Model: RN-MF2/RN-P2	Date: 15-Mar-12	No.: RM118001
----------------------------	-----------------	---------------

Subject: Firmware Release Note: Engine		Prepared by: Y. Gaman	
From: 3rd Tech Service Sect., MFP/Printer Tech Service Dept.			
Classification:	<input type="checkbox"/> Troubleshooting <input type="checkbox"/> Mechanical <input type="checkbox"/> Paper path <input type="checkbox"/> Product Safety	<input type="checkbox"/> Part information <input type="checkbox"/> Electrical <input type="checkbox"/> Transmit/receive <input checked="" type="checkbox"/> Other (Firmware)	<input type="checkbox"/> Action required <input type="checkbox"/> Service manual revision <input type="checkbox"/> Retrofit information <input checked="" type="checkbox"/> Tier 2

Model: RN-MF2		Date: 15-Oct-12	No.: RM118004
Subject: I-Fax POP3 fails		Prepared by: Y. Gaman	
From: 3rd Tech Service Sect., MFP/P Tech Service Dept.			
Classification:	<input checked="" type="checkbox"/> Troubleshooting <input type="checkbox"/> Mechanical <input type="checkbox"/> Paper path <input type="checkbox"/> Product Safety	<input type="checkbox"/> Part information <input type="checkbox"/> Electrical <input type="checkbox"/> T

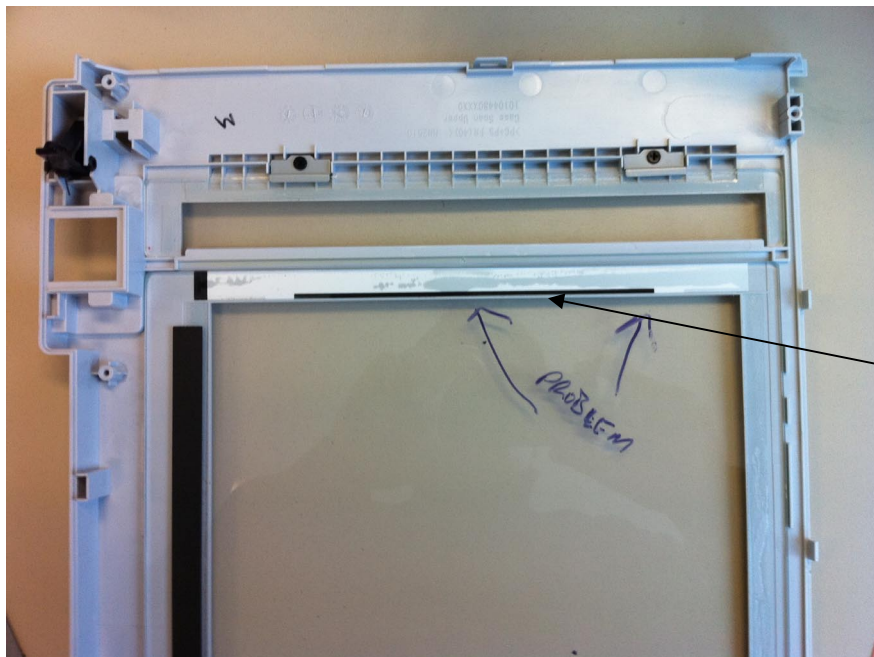
White stripes may appear on copies.

The glue that fixes the calibration white plate to the edge of the exposure glass melts. As a result, it leaks out and is picked up by the scanner.

Note: The glue tends to melt when the temperature and humidity are high (40C/90%), and when the exposure glass is cleaned with alcohol.

Glue melted

Upper Scanner Case

1. The following were added to the production process from September 25, 2011.
 - No cleaning solvents (including pure alcohol) are used to clean the shading sheet, exposure glass, and upper scanner case.
 - A visual check is performed to make sure that glue cannot be seen between the exposure glass and white plate, after the glue has dried.
2. A new type of glue is used to attach the white plate. This glue will not melt in high-temperature, high-humidity conditions, nor by cleaning solvents.

In accordance with this change, the part number for the upper scanner case was changed as follows:

1. If the symptom occurs, replace the upper scanner case or scanner unit.
2. To prevent occurrences, do the following:
 - Do not use cleaning solvents (including pure alcohol) to clean the white plate, exposure glass, or internal area around the scanner unit.
 - Advise customers not to use cleaning solvents (including pure alcohol) to clean the exposure glass. Rather, as mentioned in the User Guide, advise them to clean it with a soft, damp cloth and then dry it with the dry cloth.
 - Advise customers to turn Energy Saver mode ON. This is because if it is OFF, the temperature around the scanner unit will tend to increase.

U006.PAPER FEED

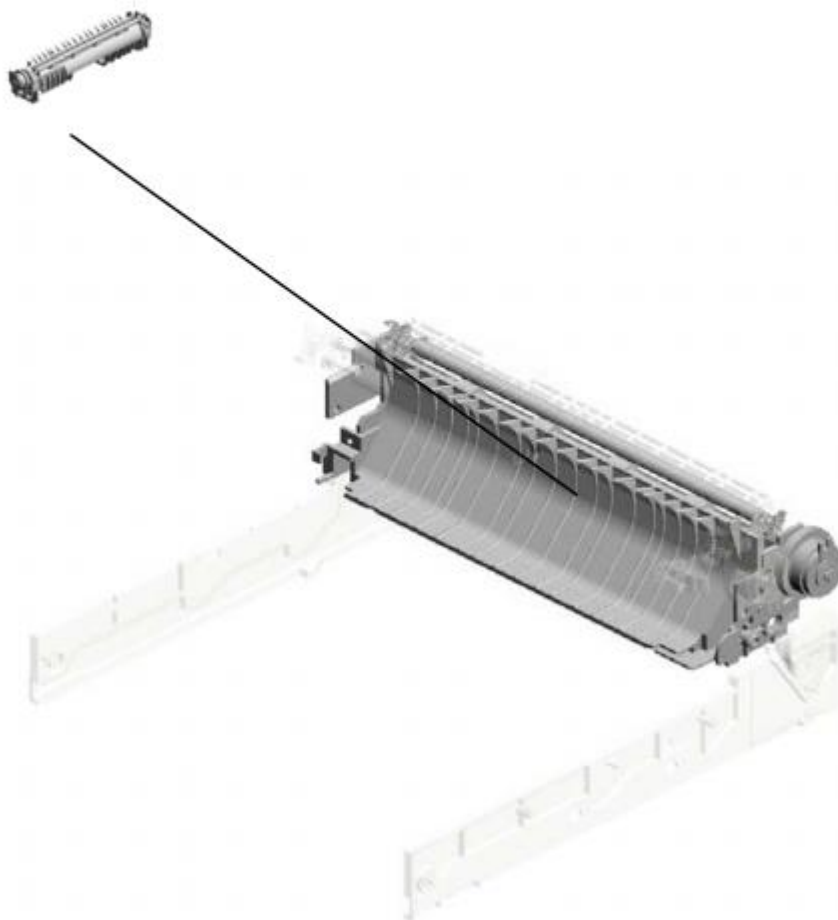
JOINT UNIT: ASS'Y is available as a spare part.

U006 S001
M1172516
JOINT UNIT:ASS'Y
